66000A-07

S E R V I C E N O T E

66000A MODULAR POWER SYSTEM MAINFRAME - 8 SLOTS, GP-IB

Figure 3 Regal Non locking Nut

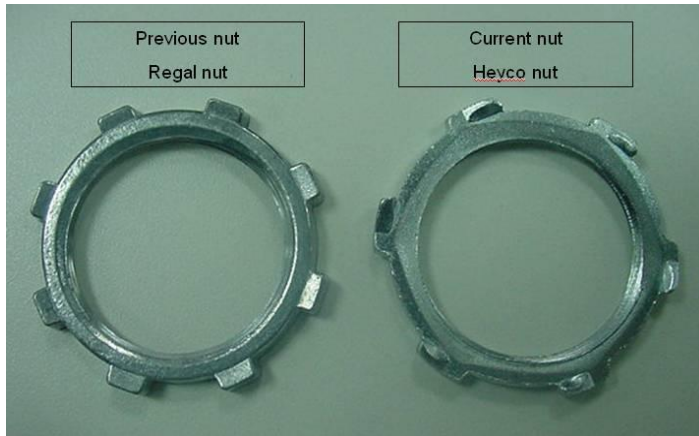
Figure 2 shows the inside of the AC Safety Cover housing the incorrect hardware is shown. It will be very difficult to tighten the strain relief. AMC (Asian Manufacturing Center) uses a special tool to tighten the locking nut. When the incorrect nut is used or a locking Nut is put on incorrectly the strain relief will become loose as described above.

Figures 3 & 5 is representative of a not without locking ribs.

The entire AC **INPUT SAFETY COVER** P/N 5040-1676 should be replaced.
